Access Compliance Report

Public Rights-of-Way

(Curb Ramps)

Intersection ID: 27570	Main Street: ALTON_FARM_LN	Cross Street: DEER RIDGE_LN	Location: E
ADA ID: 116242AF4F9A	Ramp Type: Perp	Initial Pass/Fail: Fail	Overall Compliance: No
Severity Score: 21.25			
Codes/Mitigation Info/Possible Solution		Field Measurements/Component Compliance

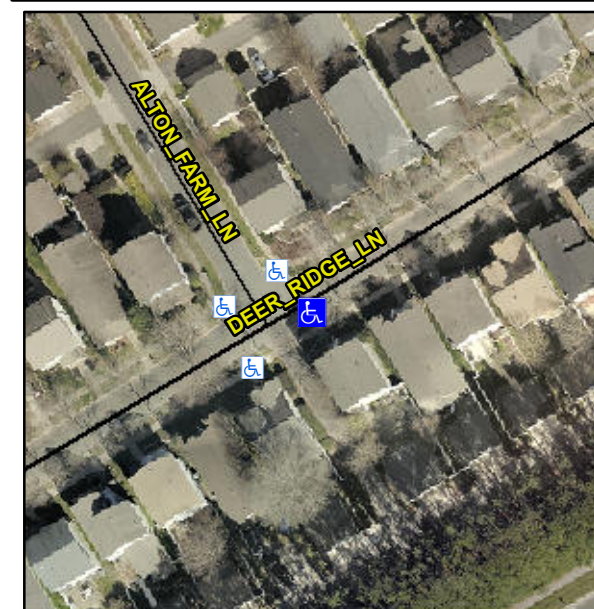
Not Found, R304.5.1, R304.2.2

Compliance	Description	Data	Compliance	Description	Data
N/A	Ramp Length (in)	60.0	No	Ramp Slope (%)	11.8
No	Ramp Width (in)	47.5	Yes	Ramp XSlope (%)	1.1
N/A	Flare Type LT	N/A	N/A	Flare Type RT	N/A
N/A	Flare Slope LT (%)	N/A	N/A	Flare Slope RT (%)	N/A
N/A	Flare Traversable LT?	N/A	N/A	Flare Traversable RT?	N/A
N/A	Landing Length (in)	N/A	N/A	DWS Provided?	N/A
N/A	Landing Width (in)	N/A	N/A	DWS Contrast?	N/A
N/A	Landing Slope (%)	N/A	N/A	DWS Length (in)	N/A
N/A	Landing X Slope (%)	N/A	N/A	DWS Full Width?	N/A
N/A	Landing Curb? (Y/N)	N/A	N/A	DWS Offset (in)	N/A
N/A	Shared Landing?	N/A			
N/A	Gutter Ponding?	N/A	N/A	Gutter Slope (%)	N/A
N/A	Gutter Lip Ht (in)	N/A	N/A	Gutter X Slope (%)	N/A
N/A	Painted X Walk1?	No	N/A	Painted X Walk2?	N/A
	X Walk 1 Direction	To NW		X Walk 2 Direction	N/A
N/A	X Walk 1 Width (in)	N/A	N/A	X Walk 2 Width (in)	N/A
	X Walk 1 Slope (%)	2.1		X Walk 2 Slope (%)	N/A
	X Walk 1 X Slope (%)	2.3		X Walk 2 X Slope (%)	N/A

Remove & Replace Entire Ramp.
